820DIFF By Mitchell Mlinar 10/6/85

This small file is a composite difference description between the 820-I Etch 1 and 820-I Etch 2. An assumption is made that you have one or the other (hopefully, both) of the 820 schematics. In addition, I would like to thank Dan Costello for helping me out with this document by providing some nicely drawn difference schematics to work from.

PROCESSOR CLOCK

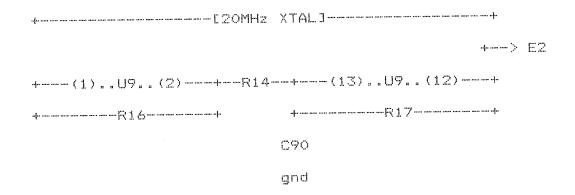
The clock and clock driver are slightly different between the two versions.

ETCH 1: R16, R17 = 1k

C90 = 47pf

U9 = 74LS04

C192 = .01uFC92 = 100pF

$$R14 = 100$$

$C90 = 47pF$

$$U9 = 74LS04$$
